# K60XV MANUAL ERRATA

Rev. **B-1,** July 9, 2012

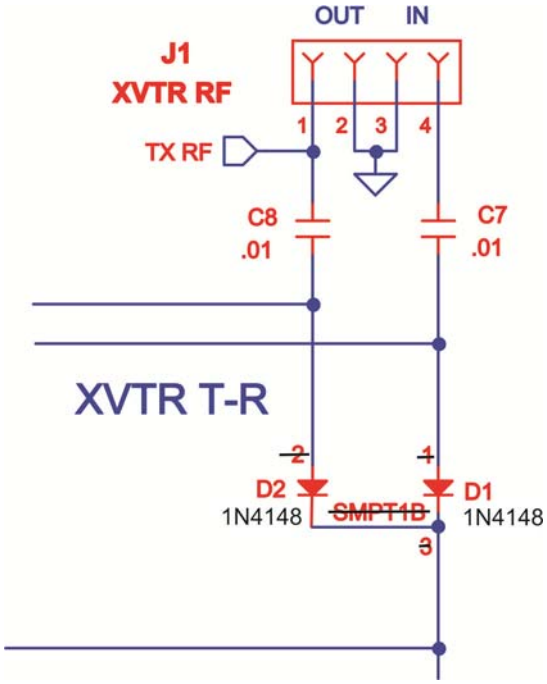
1. **Page 3, Parts Inventory, Ref D1-D2:** Change the description to read "Diode 1N4148". Change the part number to "E560002".
2. **Page 4, add the following step after the second checkbox step:**

☐ Install diodes D1 and D2 (1N4148). Orient the banded end (cathode) of each diode as indicated by its component outline.
3. **Page 6:** Delete the second and third checkbox steps (the SMT1B board is no longer used).
4. **Page 20:** On the schematic diagram, update the upper right corner with the changes shown below around D1 and D1:
